ABBREVIATED PLAT AGENDA ASSEMBLY CHAMBERS 350 EAST DAHLIA AVENUE, PALMER

STAFF REVIEW AND RECOMMENDATIONS PUBLIC HEARING JUNE 25, 2025

SHARI'S ACRES 2025

CASE #: 2025-75

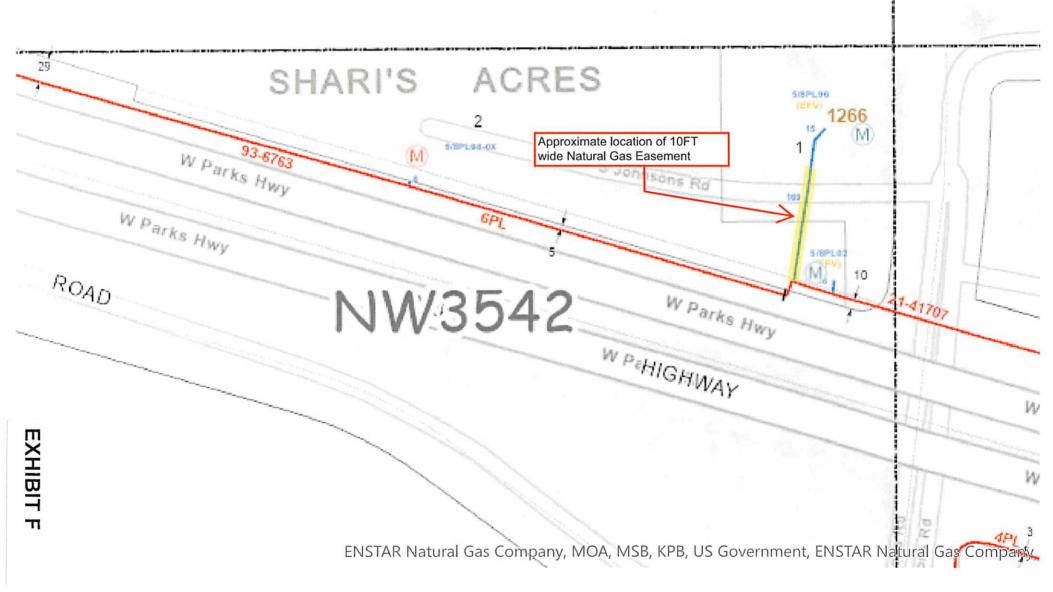
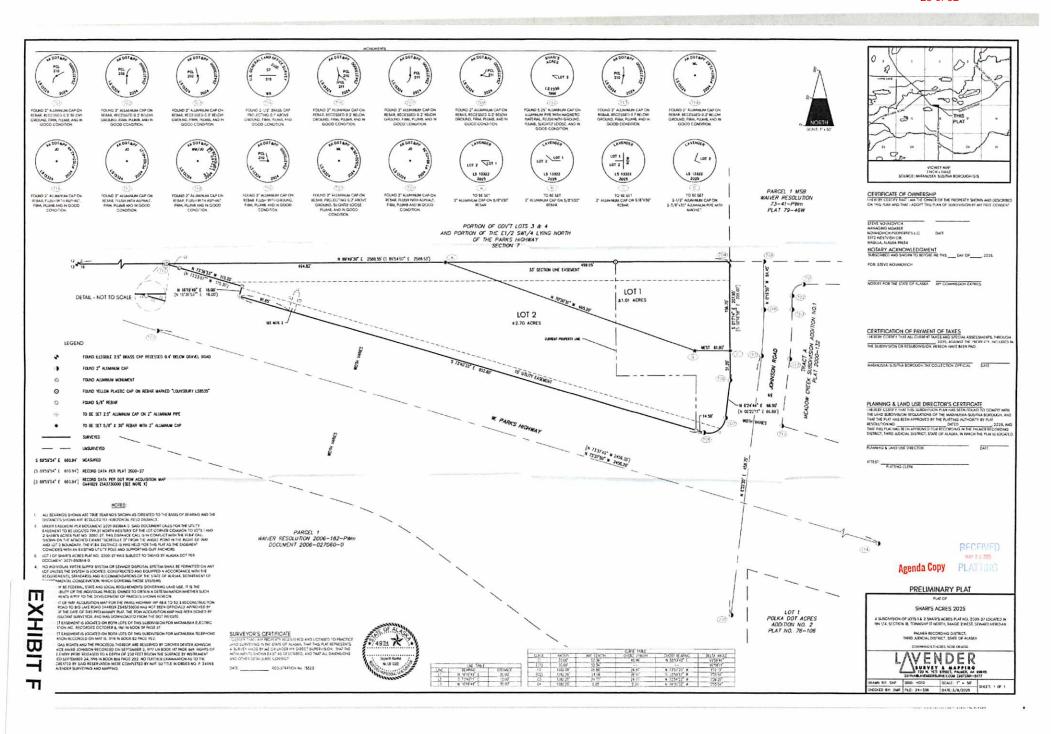
ENSTAR Natural Gas Company, LLC has reviewed preliminary plat SHARI'S ACRES 2025 (MSB Case # 2025-075) and advises that there is an existing natural gas service line which appears to cross proposed Lot 2 to serve proposed Lot 1. Attached is an as-built for you reference. ENSTAR objects to this plat unless one of the following scenarios is met:

- 1. Add a note which says, "There is a ten foot (10 FT) wide natural gas easement centered on the existing service line." And draw in the location of the service line on the map and add, "Location of natural gas service pipeline and centerline of ten foot (10 FT) wide natural gas easement".
- 2. Owner signs an ENSTAR Natural Gas Easement document for a ten foot (10 FT) wide natural gas easement, centered on the service line at this location.

- 7. Add a note which says, "There is a ten foot (10 FT) wide natural gas easement centered on the existing service line." And draw in the location of the service line on the map and add, "Location of natural gas service pipeline and centerline of ten foot (10 FT) wide natural gas easement".
